Kansas Department of Agriculture
 Division of Water Resources
CHANGE: P/D WORKSHEET

KANSAS DEPARTMENT OF AGRICULTURE
Division of Water Resources
MEMORANDUM

DATE: July 5, 2016
RE: Water Right
File Nos. 452 and 21,814

**APPROVAL OF APPLICATION
FOR
CHANGE IN
POINT OF DIVERSION
WATER RIGHT
FILE NO. 21,814**

1 Mile Circle for Water Right Nos. 452 and 21814

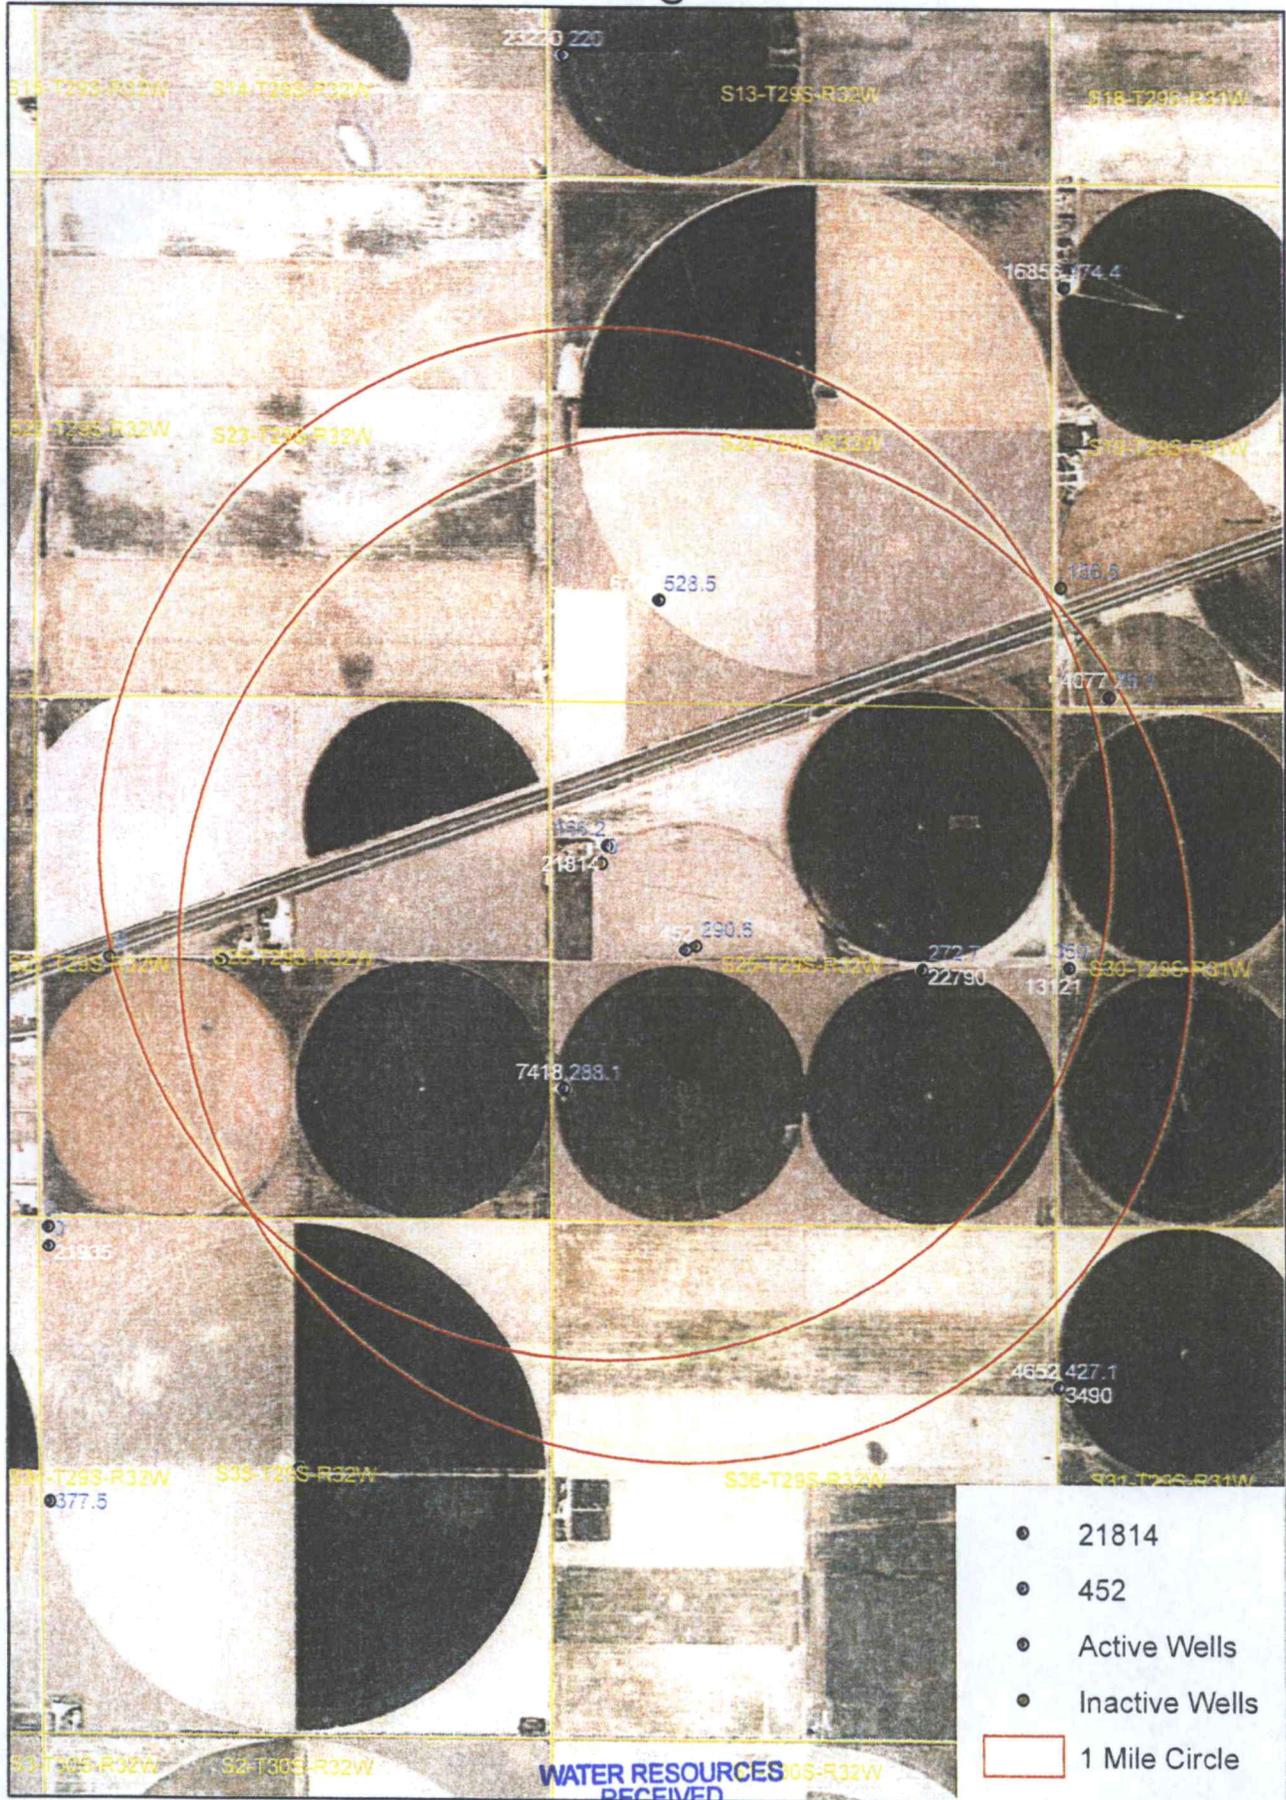
The applicant's tenant, Mike Sherwood, was able to attend the meeting to answer questions for the Board to consider. As previously stated, the spacing is not met between the two existing wells. Spacing is met to all other neighboring wells. Mr. Sherwood stated that they have gone over or been very close to using their authority on the well currently under Water Right 452, since it is the slightly better well. These two wells, along with a third are used together to water four quarters under varying sizes of center pivots. They no longer flood irrigate on any of the land. With the proposed flipping of authority between these two wells, they will be able to run the wells more efficiently they believe and save on input costs. The Board discussed the need to be sure we continue to review these applications on a case by case basis's and consider each aquifer setting. In this case the wells in question are run at almost a similar rate for their system, with the south well able to have a slightly higher rate. It was noted that these wells have not met spacing, with no known problems, and that there was no response from neighboring well owners opposing the change. With a final vote of 7 to 5, it is therefore recommended a waiver to K.A.R. 5-23-3(a)(1) be granted and that the applications be approved at this time.

Had conversation with one neighboring tenant come in to discuss the change. They did not want to stand in the way of the change and understood what the applicant was trying to accomplish. Two issues/concerns was made. 1) with the 21814 moving to the south well with the larger quantity, that could further limit them where they could redrill in the future if needed. It would cause a 200' difference in the spacing required with current rules. 2) Could this be accomplished with other tools such as a MYFA or other program?
